W3F1-2004-0086

SUBJECT: Supplement to Amendment Request NPF-38-249,
Extended Power Uprate
Waterford Steam Electric Station, Unit 3
Docket No. 50-382
License No. NPF-38

Response to Request for Additional Information

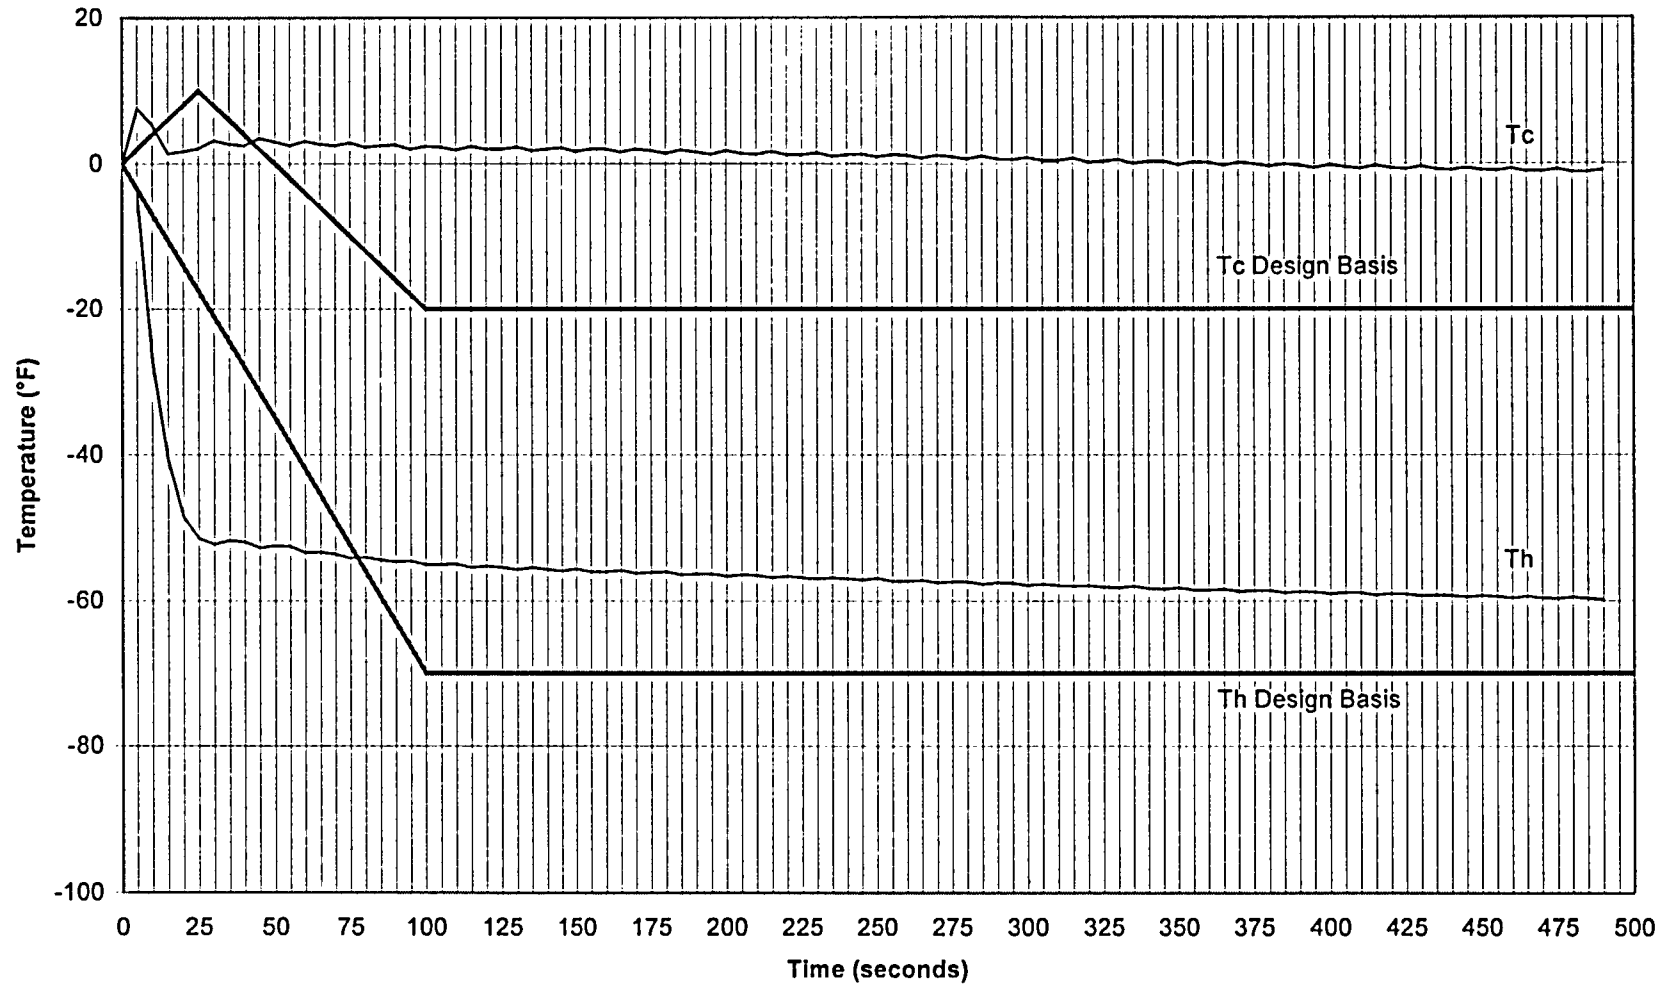
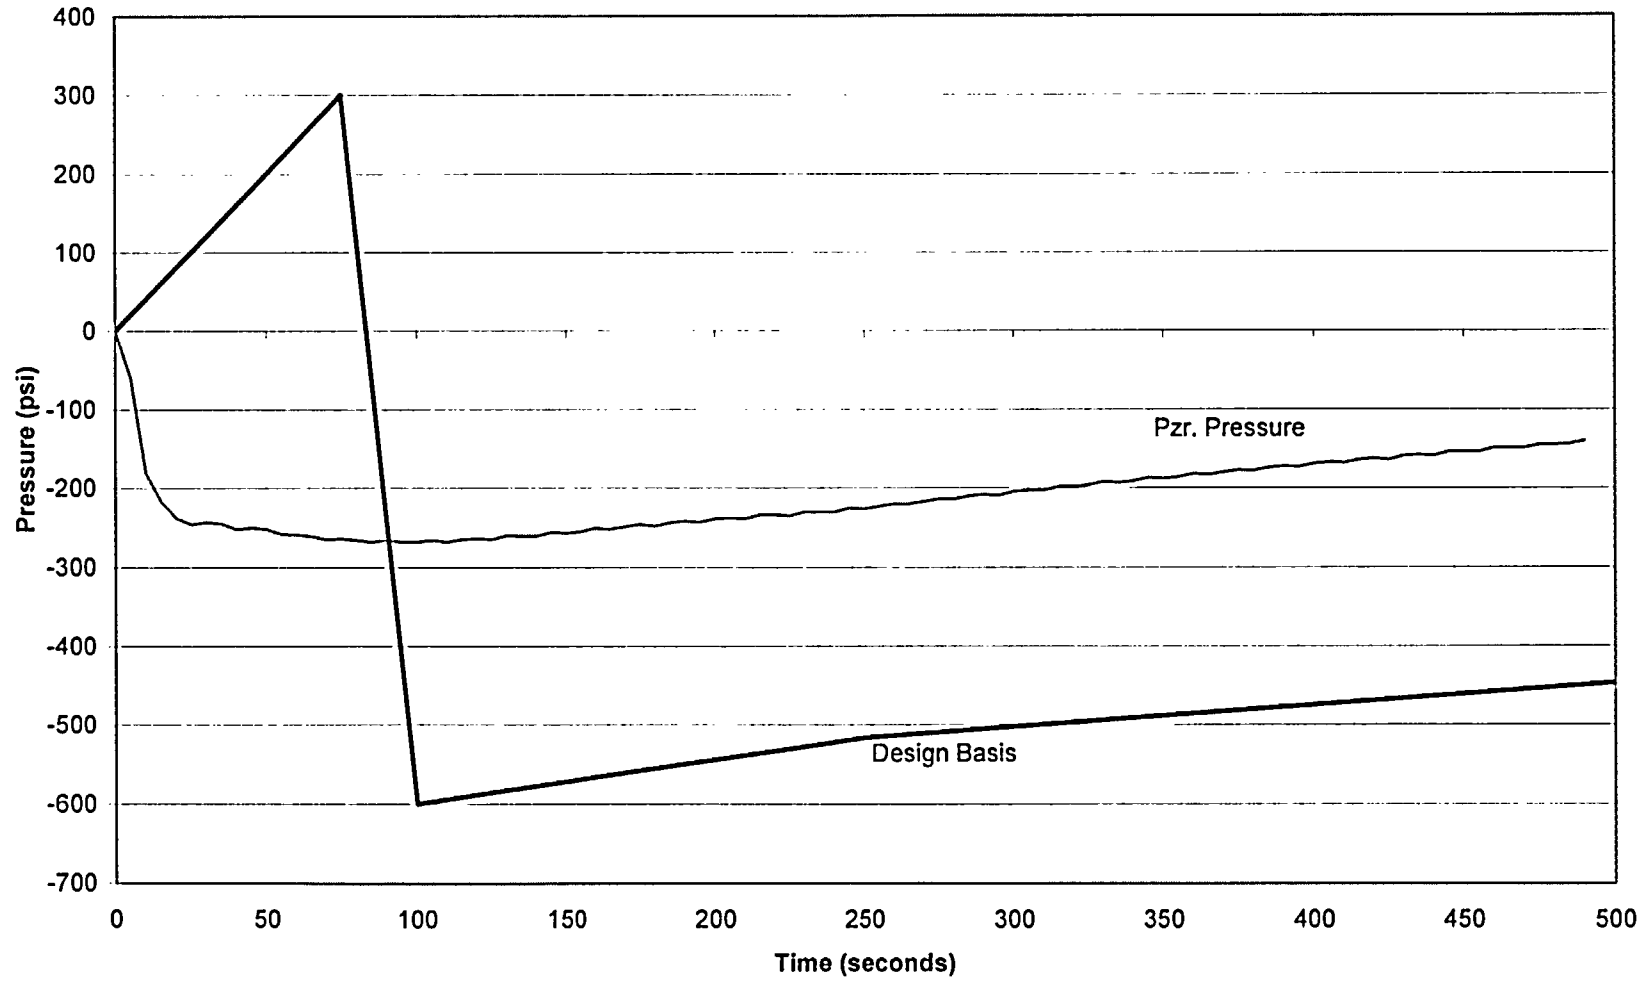
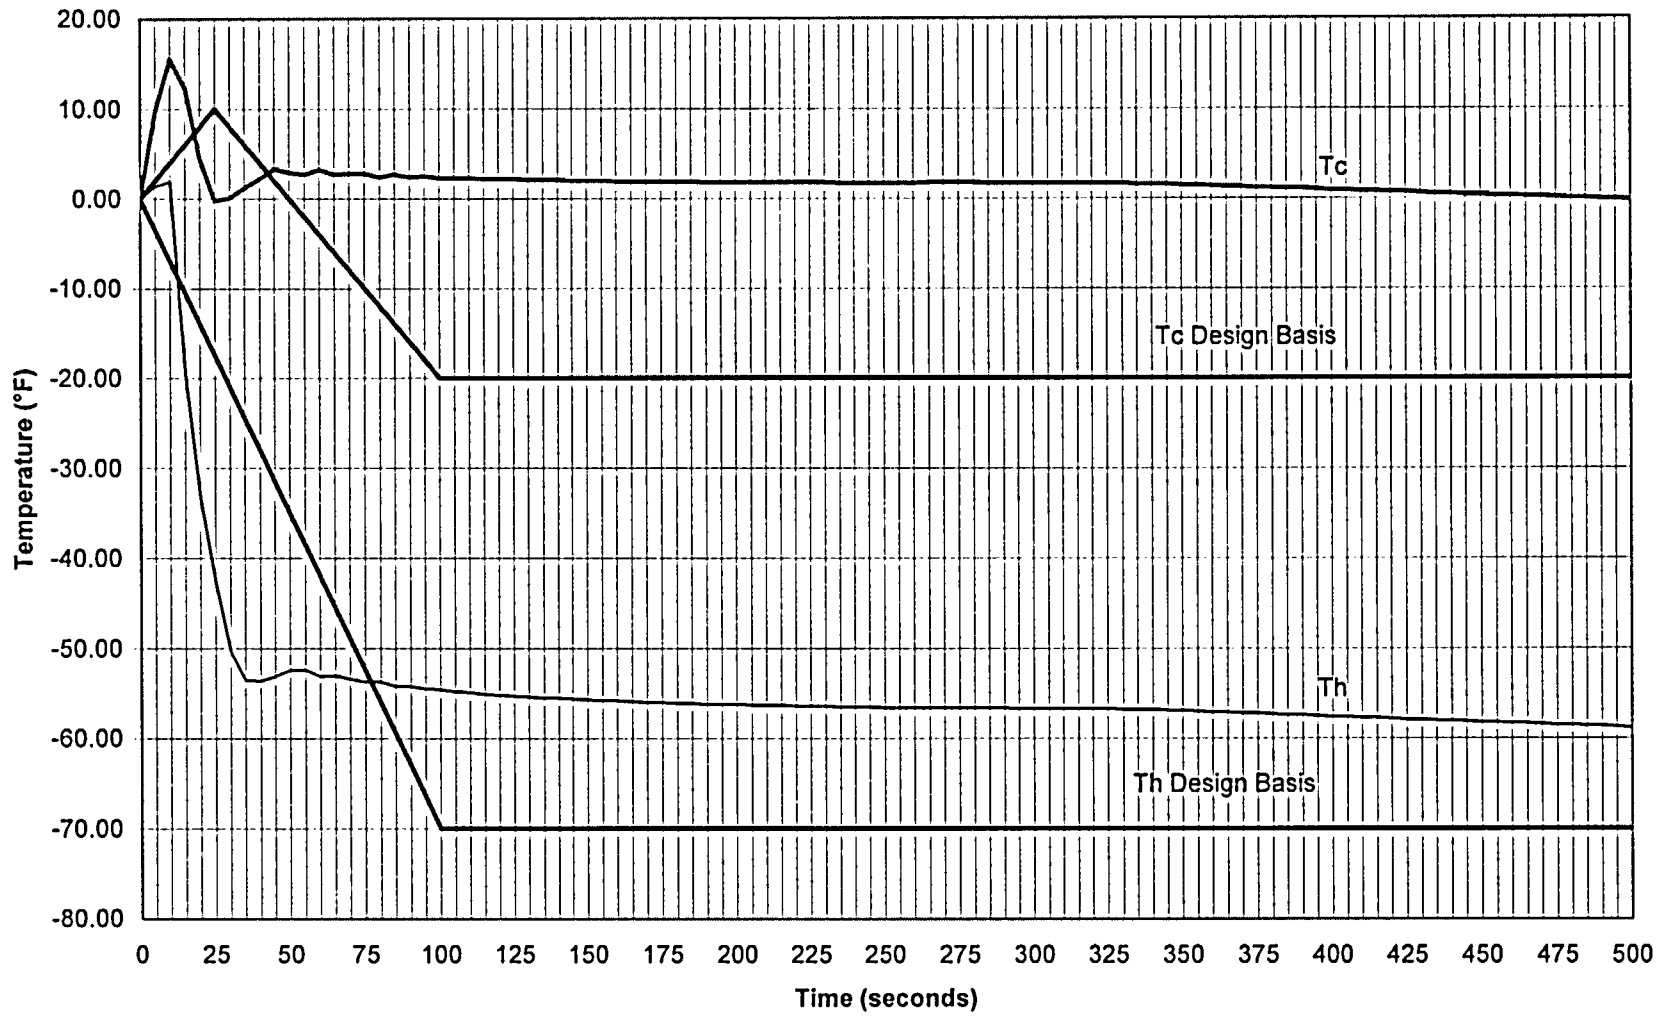
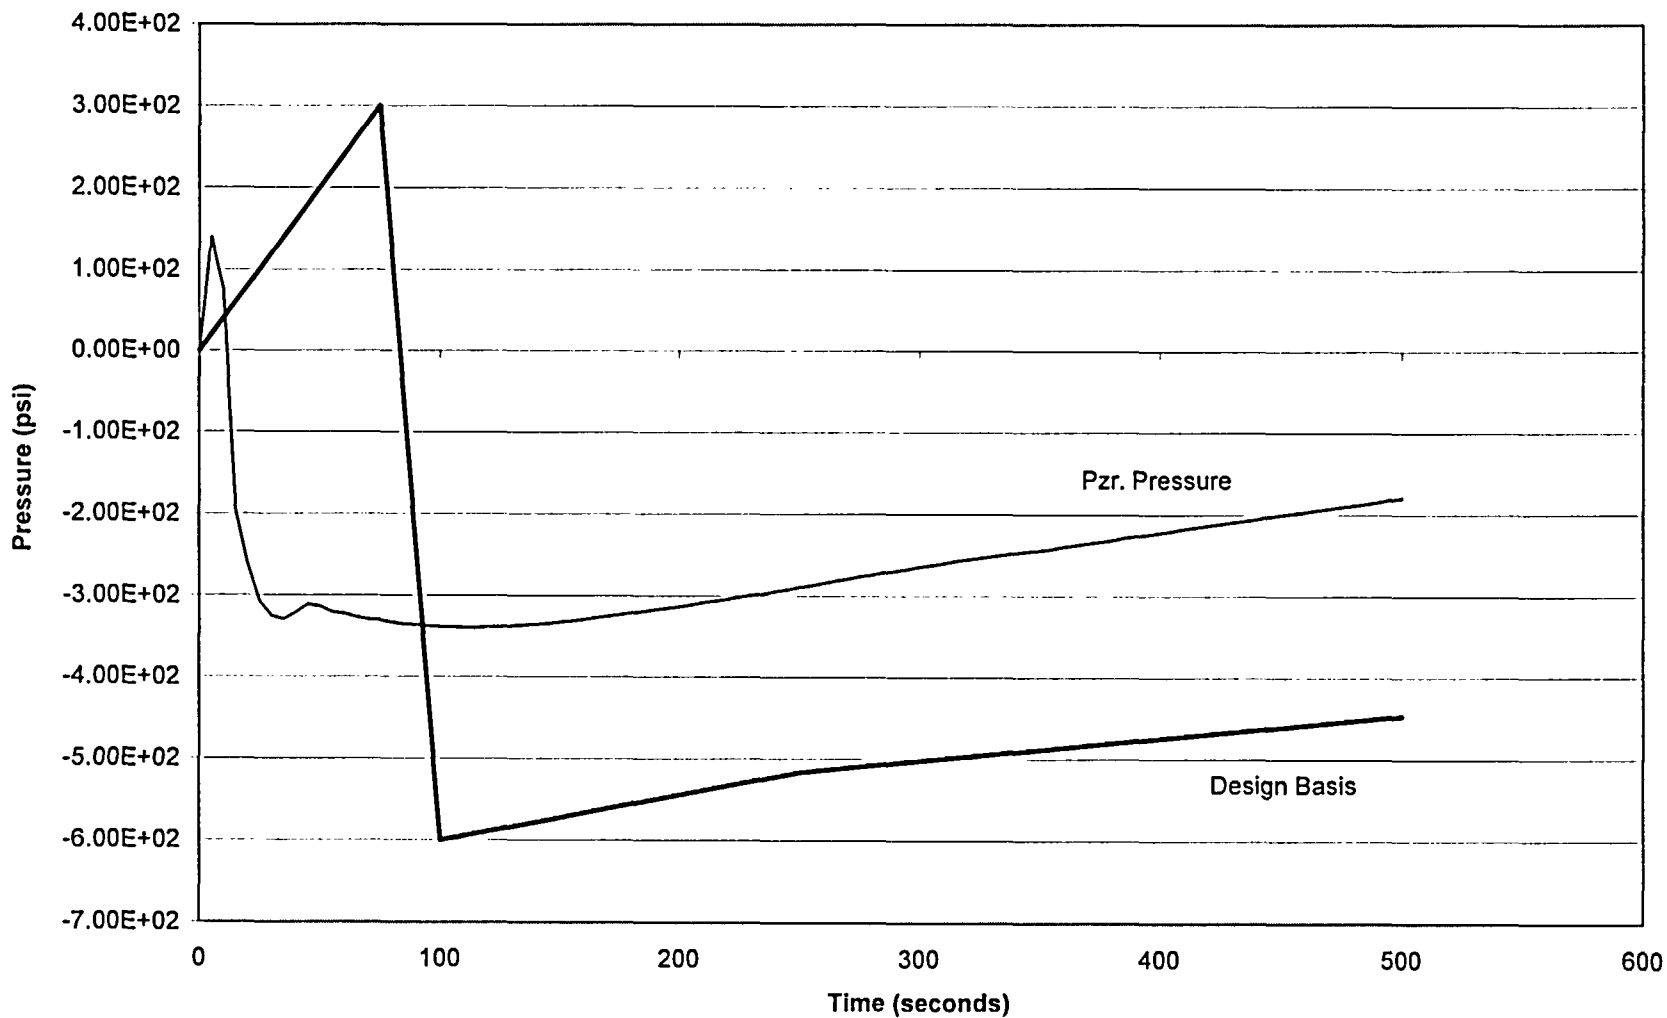
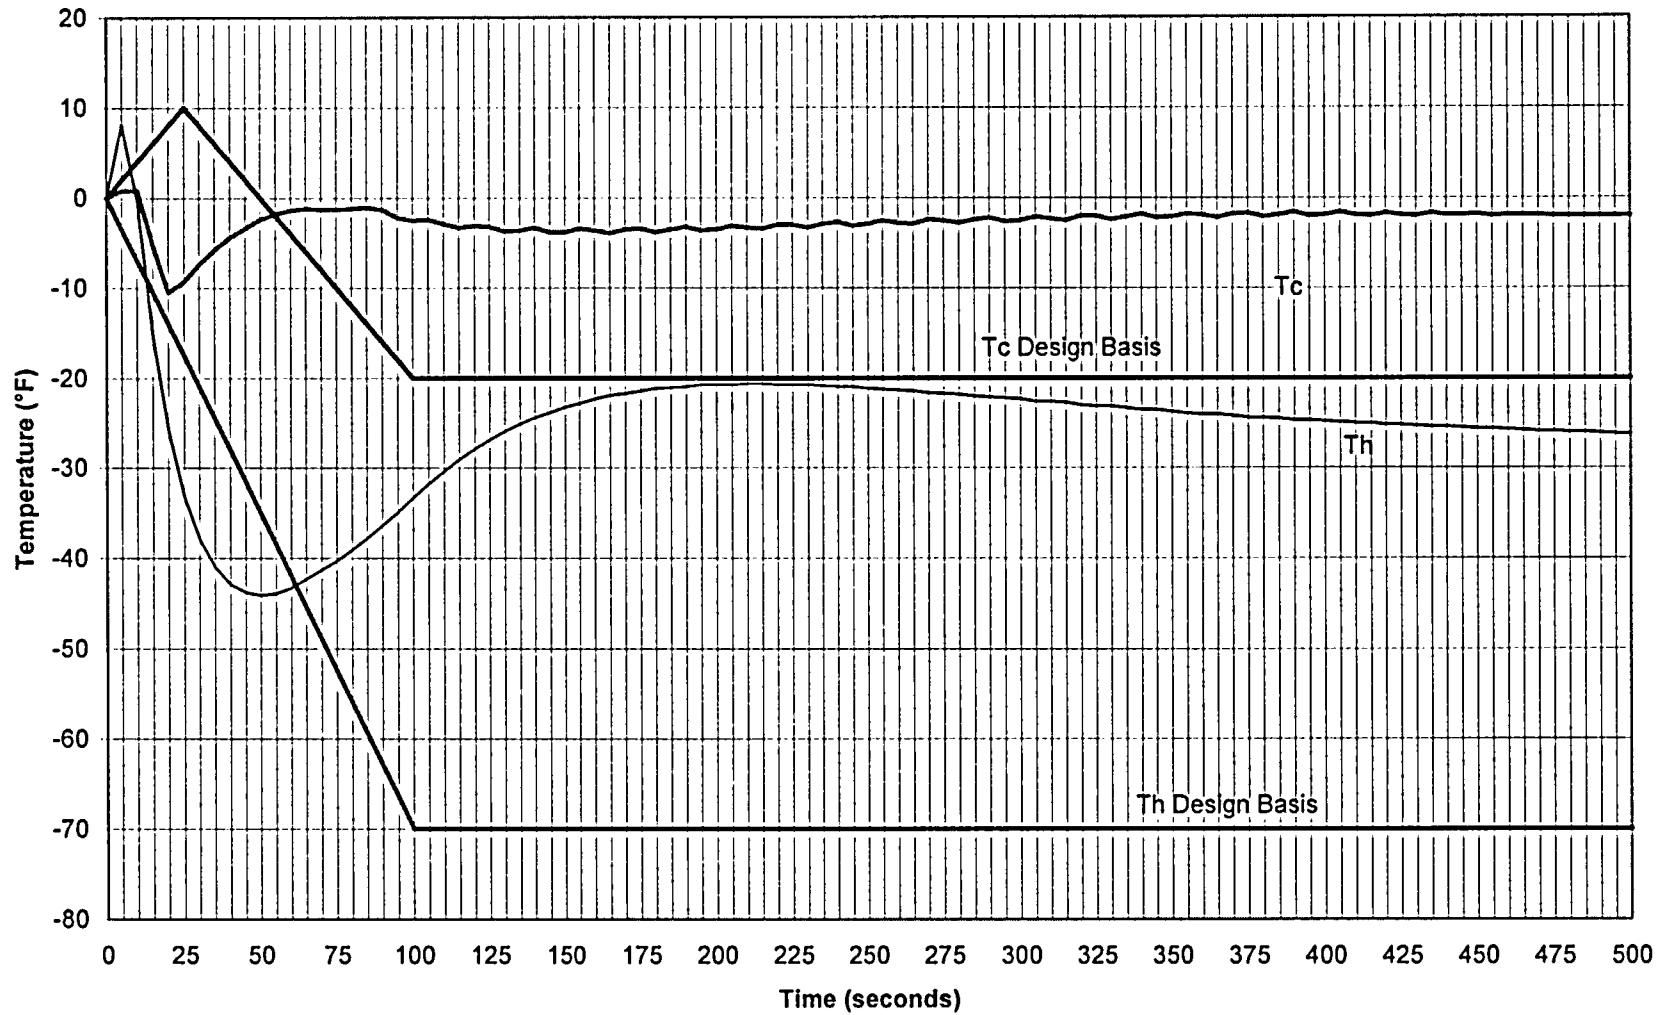
In Section 2.2.2.1.1, you indicated that power uprate resulted in minor changes to as-calculated normal operation transients, and a detailed evaluation of the changes in stresses and fatigue levels in the Reactor Coolant System (RCS) due to these transients was performed to demonstrate that the originally specified design transients for Waterford 3 remain applicable under Extended Power Uprate (EPU) conditions. This was accomplished by demonstrating that transients affected by EPU have no significant effect on the stresses or cumulative usage factors (CUFs) of the limiting RCS components. Provide a comparison of transients at the power uprate conditions to the original design-basis transients with respect to the number of occurrences and changes in pressure and temperature in the stress and cumulative fatigue usage calculations.

The originally specified design transients were evaluated for the potential effect EPU would have on them. The same list of events and number of event cycles were maintained for the EPU design transient evaluation. The Reactor Trip, Loss of Load, Loss of Flow and Loss of Secondary Pressure events were rerun using EPU conditions. The plots for the rerun cases are attached. The rerun cases and results of the evaluation were documented and evaluated for any effects on stress and fatigue levels.
